6013Permit1994 - Batch No.____

Subject: N. Mecklenburg C&D Landfill; Hydrogeology.

Subject: Hydrogeologic Considerations Response
Nov. 18th 1994

Subject: North Mecklenburg Construction and Demolition Landfill
Permit #60-13
Technical Review Letter

FIGURE 1

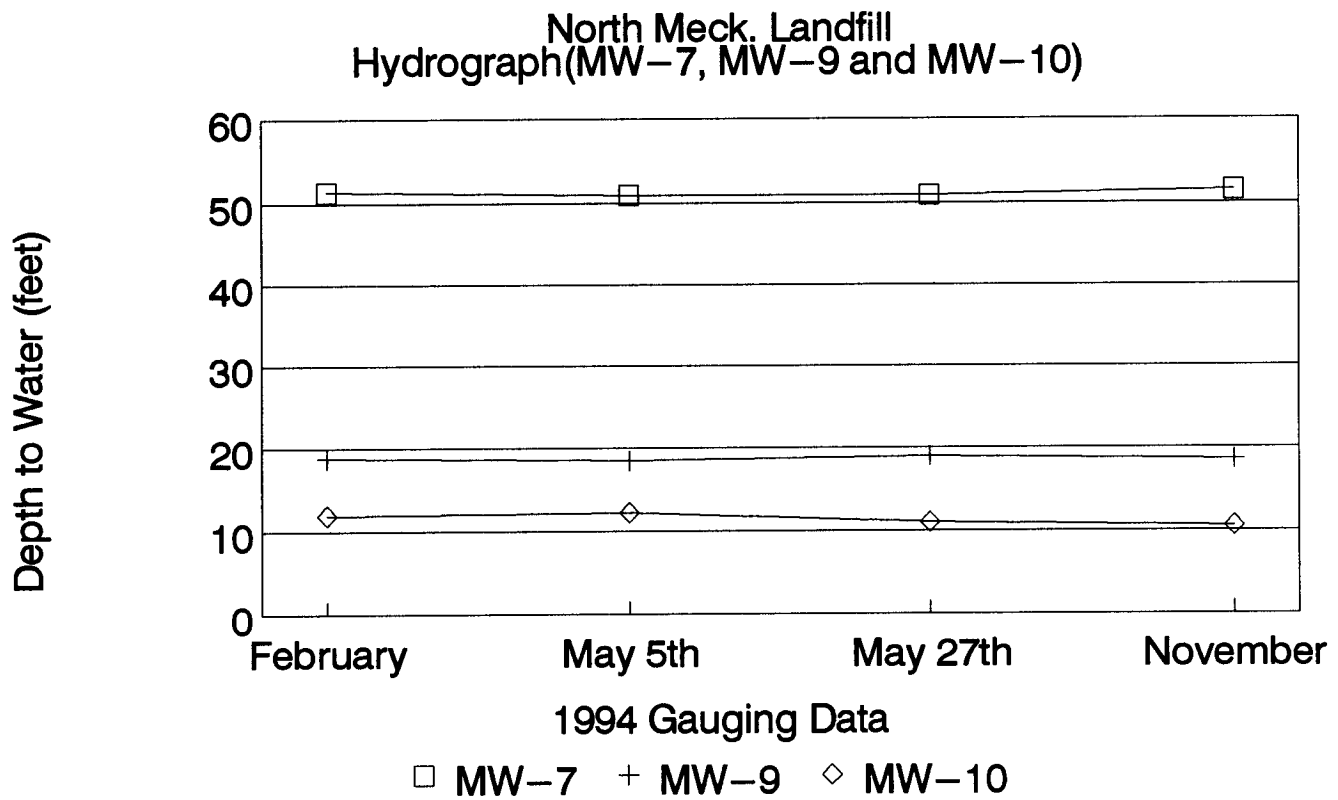
Long-term seasonal high water table levels -

Upon the submission of the ESI September 1, 1994 Report of Hydrological Assessment Addendum, ESI had compiled groundwater gauging data from February 10, 1994, May 5, 1994, and May 27, 1994. Additional gauging data of select monitoring wells was collected during in-situ permeability testing on November 9, 1994. The compilation of this data represents gauging data collected in the first, second, and fourth quarters of this year. Although gauging data was not collected during the third quarter, ESI considers this period to be a representative trend for seasonal ground water fluctuations. ESI has constructed a hydrograph of depth to water measurements for groundwater monitoring wells MW-7, MW-8, and MW-10 from gauging data collected during the previously mentioned gauging events (Figure 1). In May, wells MW-7 and MW-8 showed an increase in water table recharge which is typical for this time of year. Fourth quarter monitoring (November) indicates a seasonal low for well MW-7. The maximum change in depth to water levels within these wells is 1.65 feet.

MW-7 NOV. 9, 94

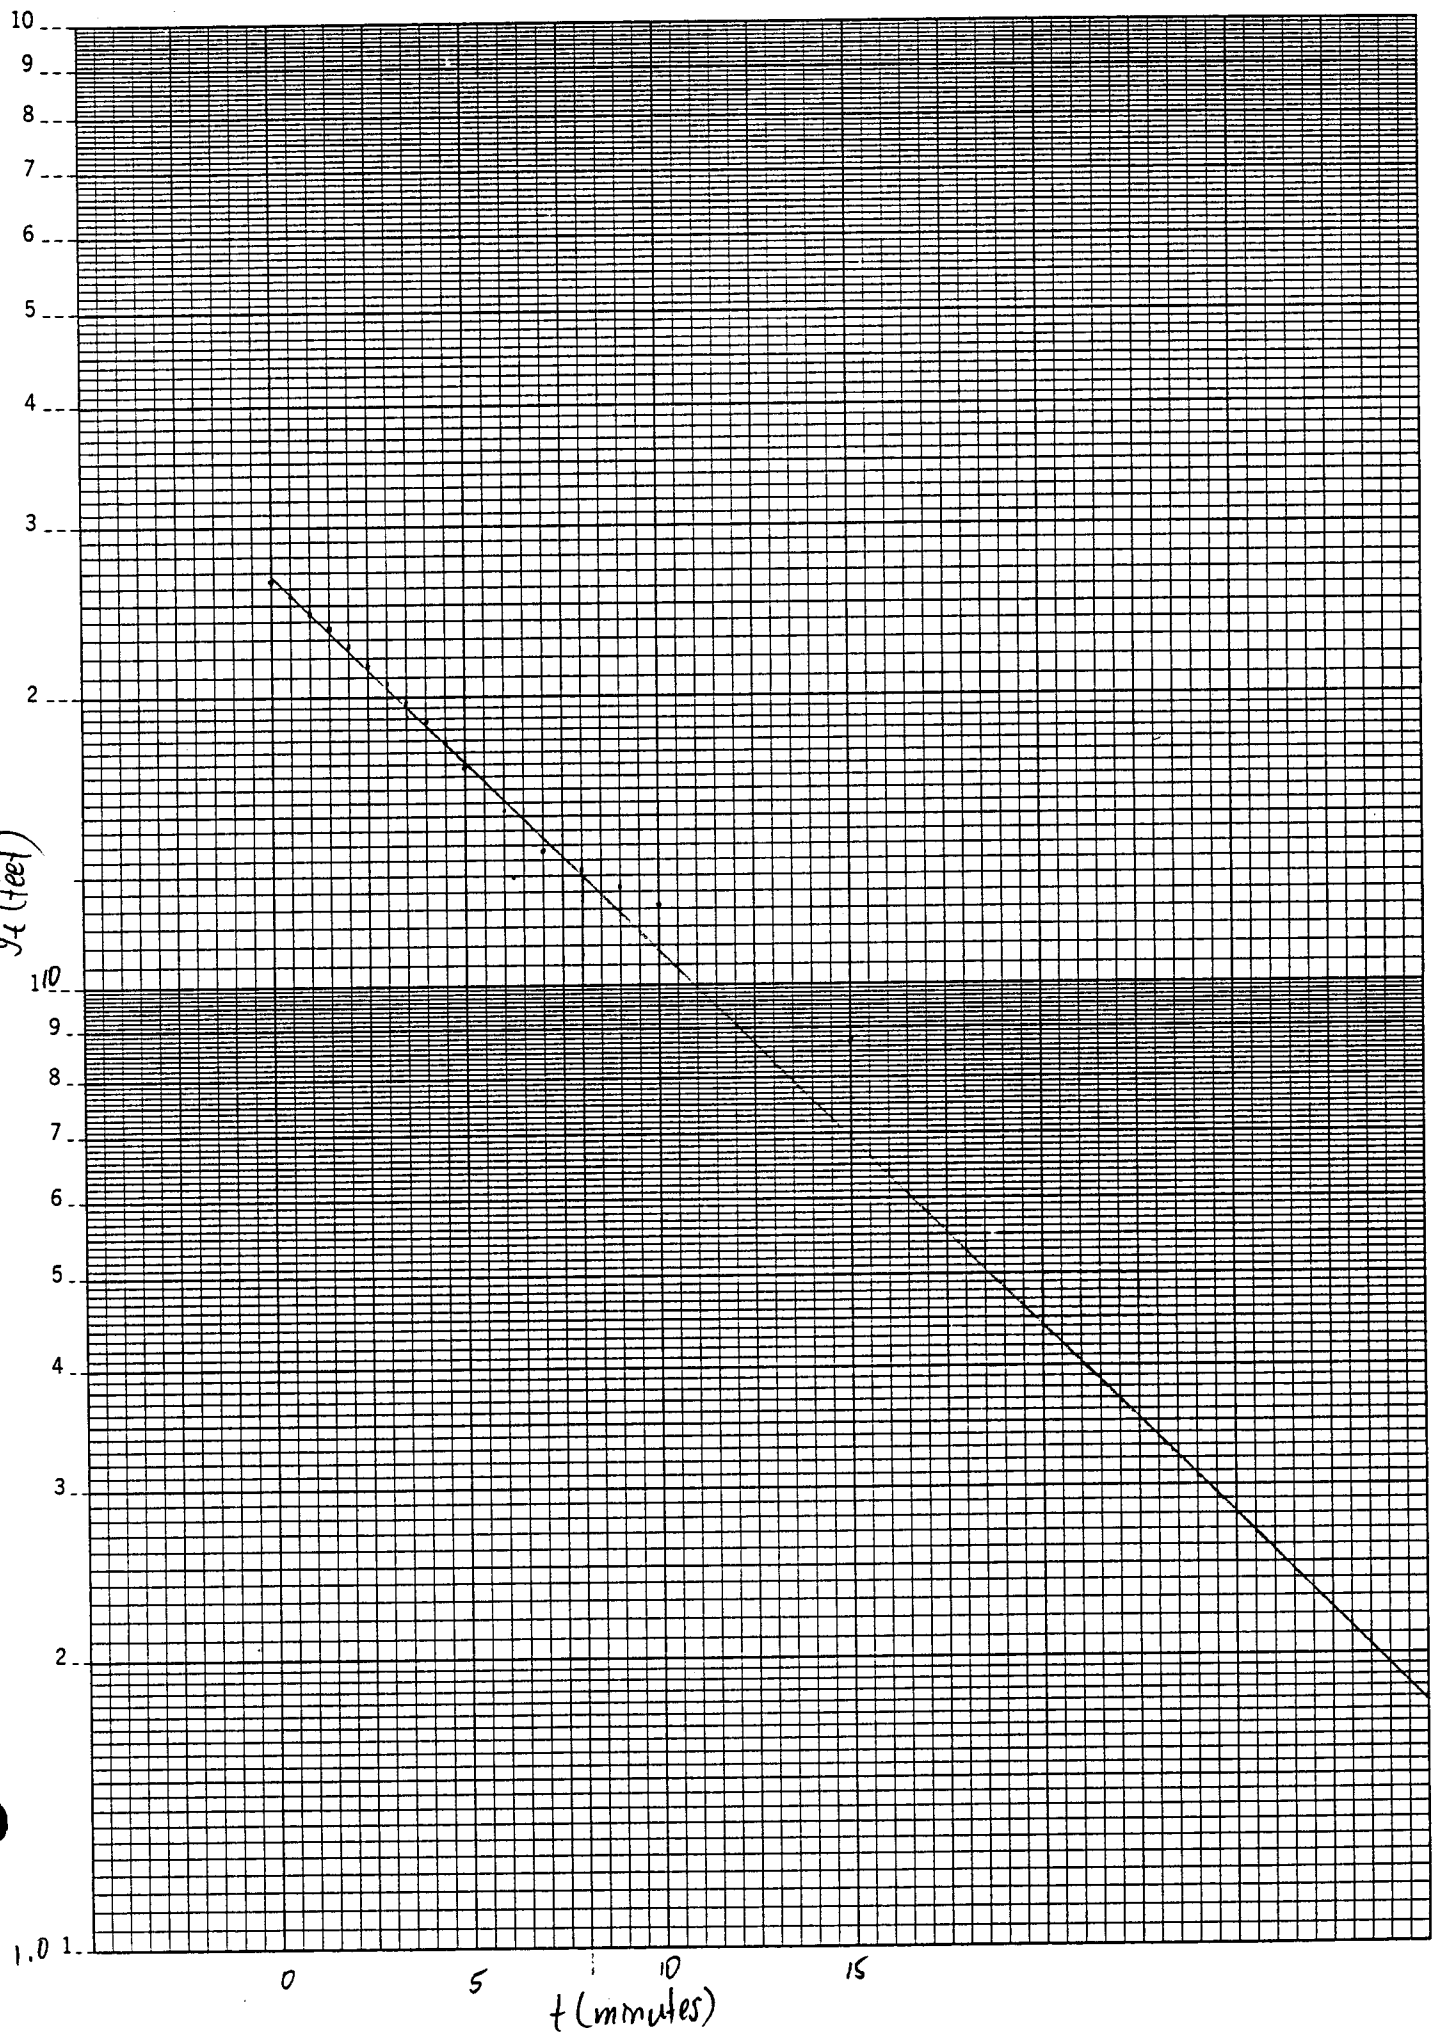
In-situ determination of hydraulic conductivity in bedrock -

In order to better characterize the hydraulic conductivity within the bedrock zone at the subject site, ESI conducted a permeability test on monitoring well MW-7. The Bouwer and Rice (1976) Method was used, assuming a partially penetrating screen and a radius which included the sand pack. The hydraulic conductivity calculated for monitoring well MW-7 is $(9.42 \times 10^{-6} \text{ cm/sec})$. Appendix A contains a graph of the in-situ permeability test and the calculations used.

MW-9

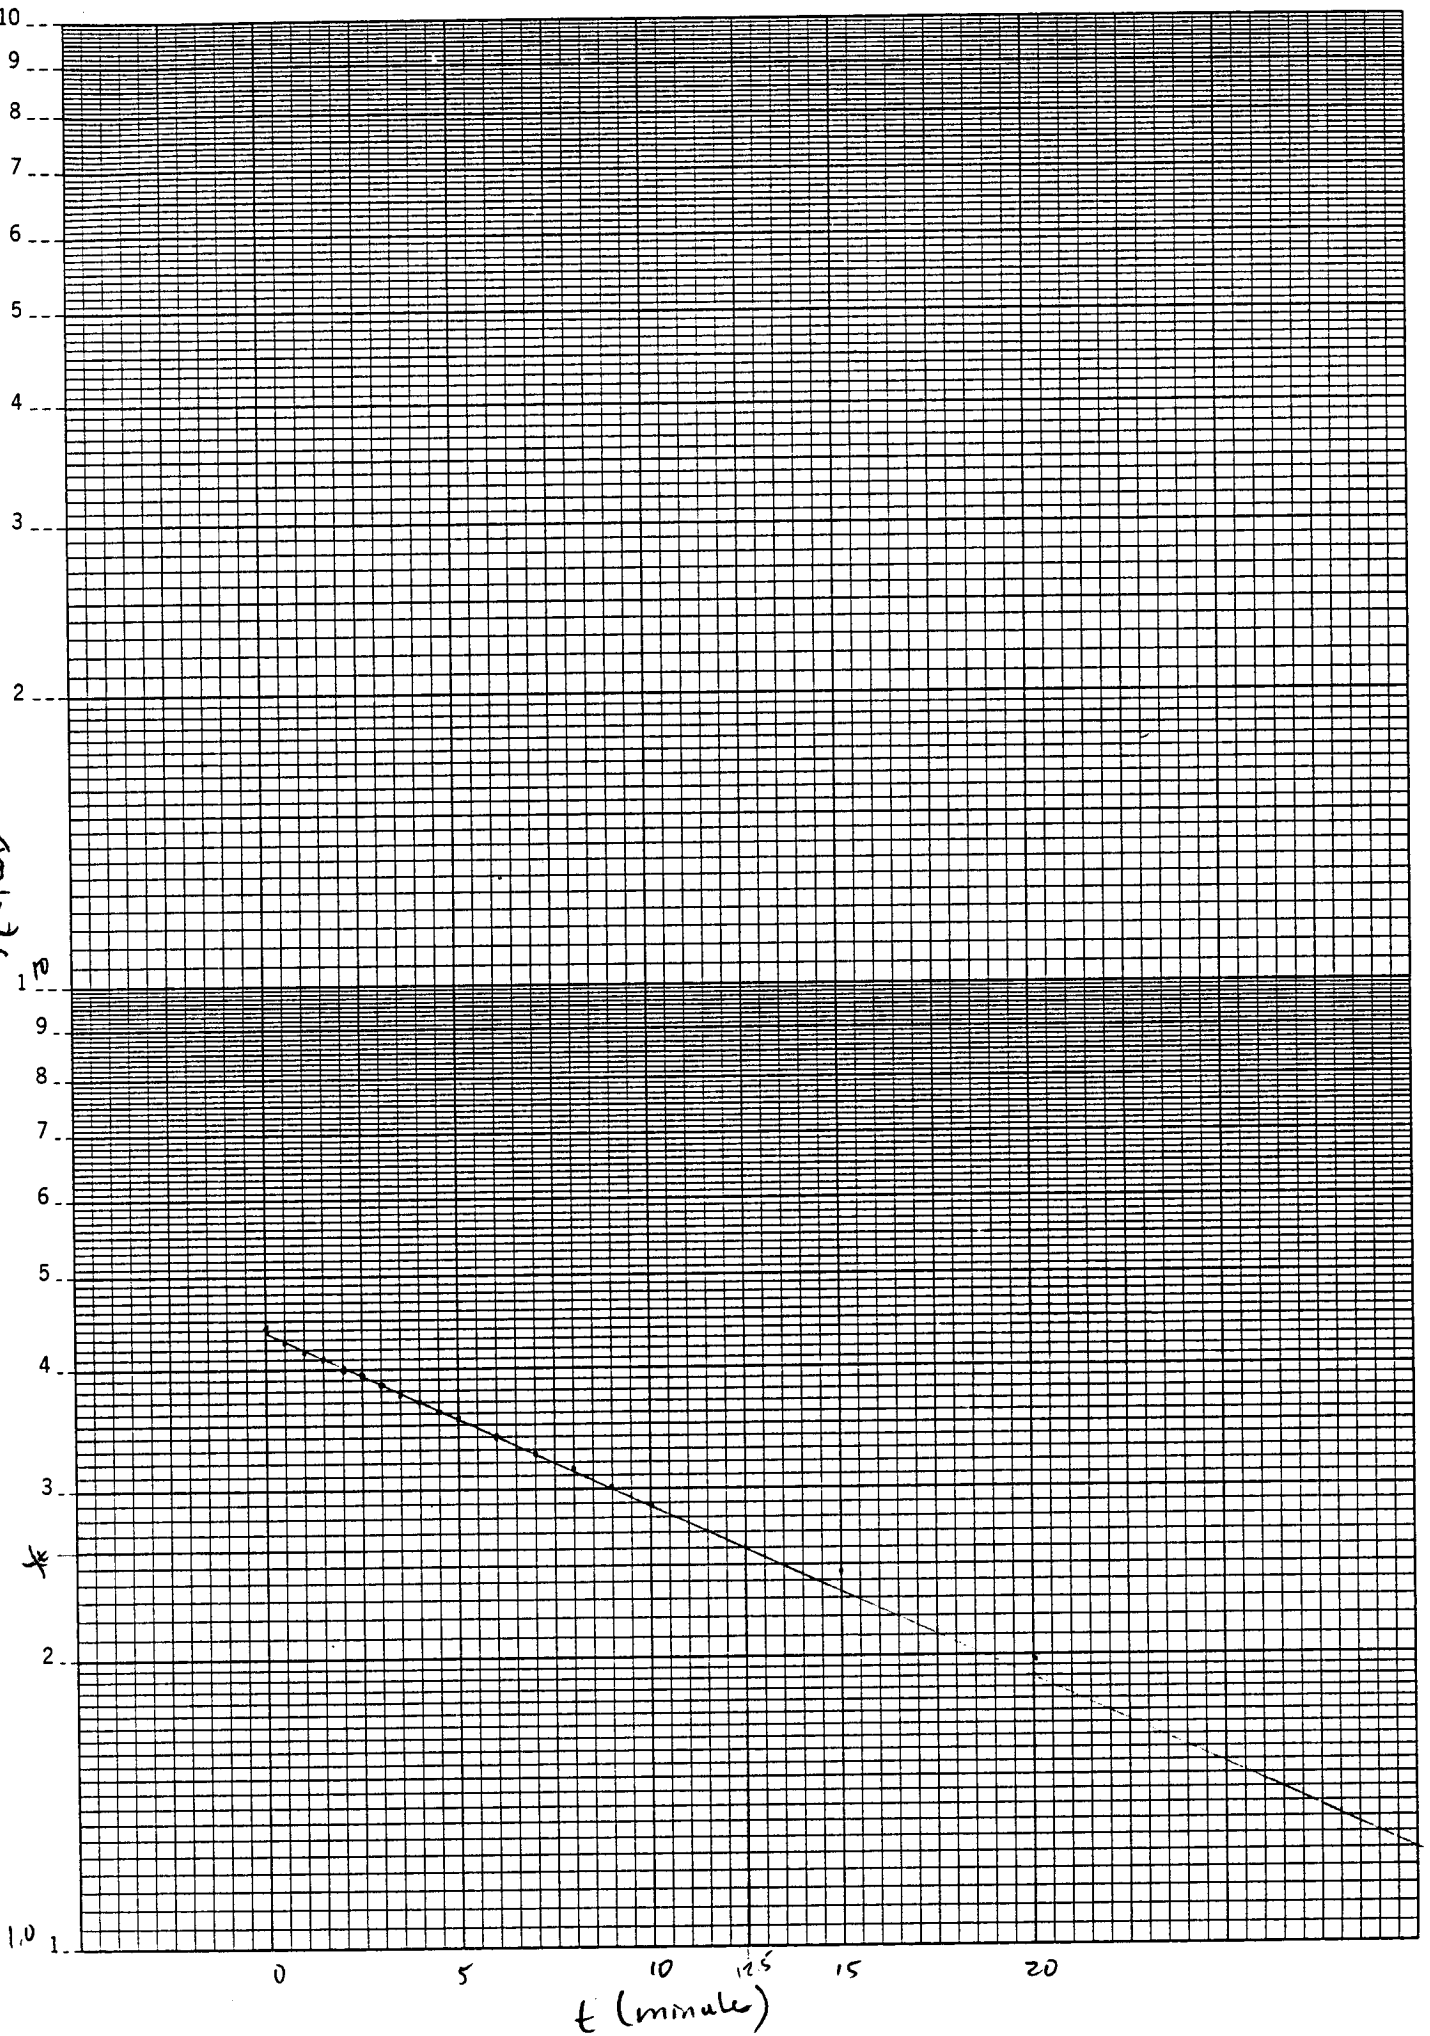
In-situ determination of hydraulic conductivity in partially weathered rock -

In order to better characterize the hydraulic conductivity within the partially weathered rock zone at the subject site, ESI conducted additional permeability tests on monitoring wells MW-9 and MW-10. The Bouwer and Rice (1976) Method was used, assuming a partially penetrating screen and a radius which includes the sand pack. The hydraulic conductivity calculated for monitoring wells MW-9 and MW-10 are $(2.64 \times 10^{-6} \text{ cm/sec})$ and $(7.92 \times 10^{-5} \text{ cm/sec})$ respectively. The higher hydraulic conductivity value calculated for MW-10 is thought to be due to the close proximity of the water holding pond located approximately 20 feet to the west. Considering this additional recharge source, this well could be considered not representative of the in-situ conditions across the remaining portion of the landfill. Appendix A contains graphs of the in-situ permeability tests and the calculations used.
